Addendum # 2

To the Contract Specifications and Drawings for:
Regional District of Nanaimo
#22-041 Whiskey Creek Water Service Area
Transmission Main and Pump Station

May 26, 2022

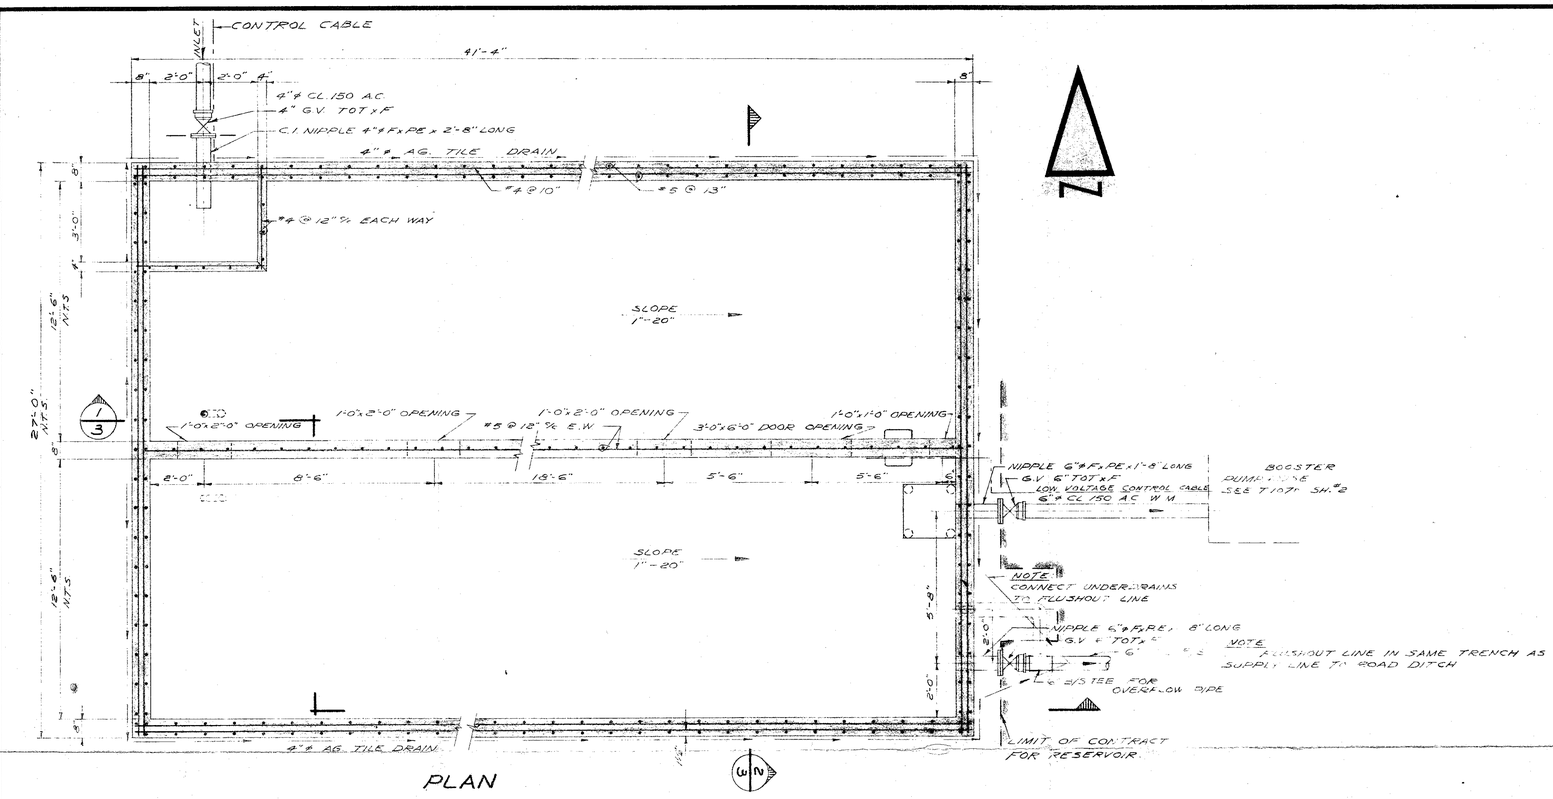
7. Question: *"The drawings show 1m spacing between the watermain and the electrical lines as shown on drawings E11.1: a. Can you please confirm this spacing is to continue all the way back to the plant? b. If so can you please confirm that paving is required down Hebert Road and Popular Way? C. Please provide a paving specification."*

Response:
   a. Yes, the 1 m separation should be maintained all the way to the plant.
   b. Yes, paving is required on both Hebert Road and Poplar Way.
   c. Asphalt material and placement must meet or exceed specified requirements as set out in Section 502 of the MC MoTI 2020 Standard Specifications for Highway Construction.

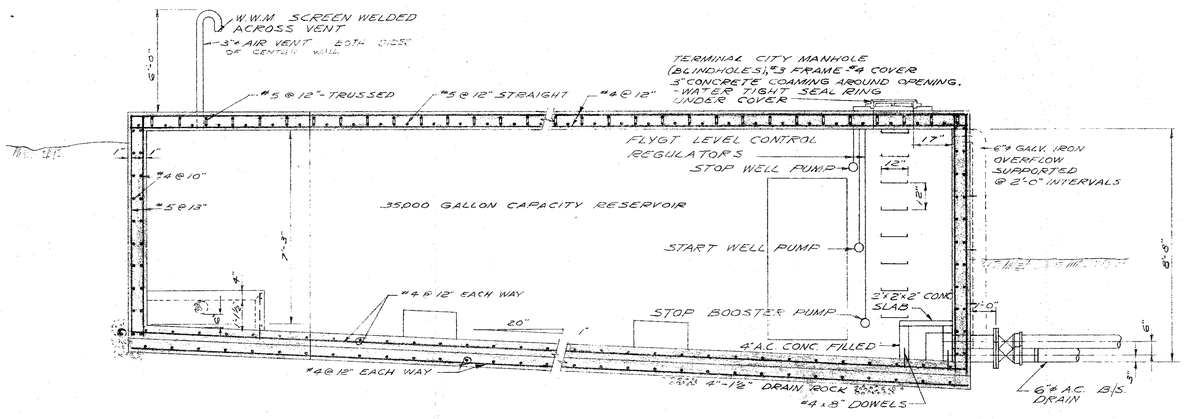
Clarification: Pavement edges must be cut, made true and straight, cleaned, and primed before installing a final patch. Where asphalt is disturbed, the distance from a pavement cut to the edge of the trench must be at least 300 mm or sufficient to ensure the pavement will not be undermined by sloughing or condition of the existing adjacent asphalt. Asphalt concrete must be restored to the same thickness as the existing surface or to a minimum of 75 mm thickness, whichever is greater. Asphaltic concrete must meet Ministry standards as set out in Section 502, Standard Specifications for Highway Construction. Asphalt concrete is to be laid in two or more lifts or layers. Each lift is to be thoroughly compacted before successive lifts are applied. The contractor will ensure that the permanent pavement patch is to the Ministry of Transportation and Infrastructure standards for one year from the date that the patch is installed. Trenches must be backfilled or adequately covered at the end of the work day,
